Beaufort County Stormwater Management Utility Board (SWMU Board)
Meeting Minutes

SUBJECT: Bluffton Gateway Development Project – Stormwater Design review

To: Eric Larson, PE Stormwater Manager
From: Tony Maglione
Date: April 11, 20014
Re: Application of 10% Effective Impervious Concept
Gateway Development, Beaufort County, SC

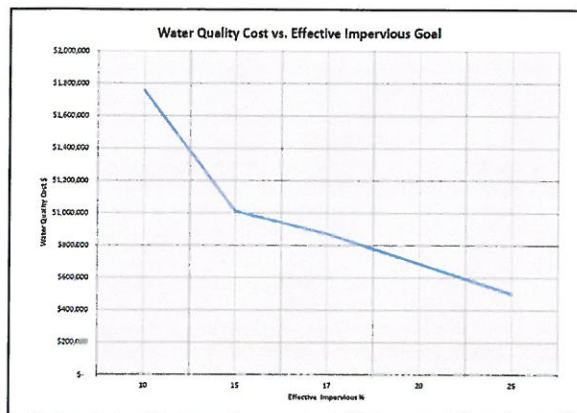
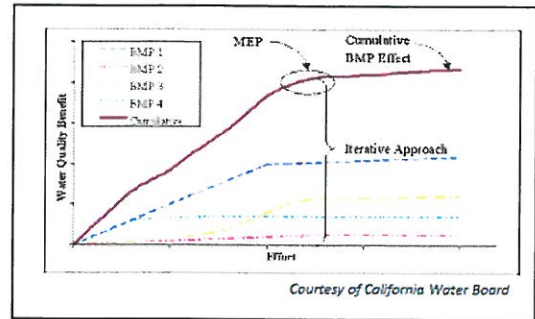
In order to assure that the capture and re-use volume is appropriate, I requested an analysis of the application of the irrigation water and drawdown of the irrigation pond. KH has quoted 2013 weather data of approx. 52" of annual rainfall, which is consistent with the generally accepted 50"/yr., 20 year average for the area. They are recommending an application rate of 1.5"/week over approx. 8.2 acres. It is also generally accepted that irrigation rates of 1" - 2" / week are acceptable for the area, therefore the recommendation is reasonable. Based on an analysis of pump drawdown and horizontal infiltration into the soil, KH has estimated that the 4" volume within the irrigation pool could be drained dry within 15 days. Given the average annual rainfall of approx. 48"-52" and a 95th percentile event of 1.95", the area averages a design storm event every 14 days. Therefore, it is a reasonable assumption that the basin will have adequate capacity to store most storm events.

The Design Review Team may choose an additional step to assure compliance with the volume reduction proposed by the applicant. In similar irrigation re-use BMPs in the County, the issuance of stormwater fee credits to several residential developments has included the condition of annual reporting to verify the minimum irrigation volume was collected and re-used over the previous year. This would give the County the opportunity to revisit the design approval should the BMP fail to function as designed.

The method of irrigation pool filling has not been clearly defined. The plan seems to indicate that the basin will fill during a 25 year design storm event through gravity flow and will be captured and prevented from release via a berm within the wet detention pond. To be effective in volume reduction as proposed, the basin will need to be designed so that the irrigation pool is filled during every storm event either by gravity or pumping from the water quality portion of the basin.
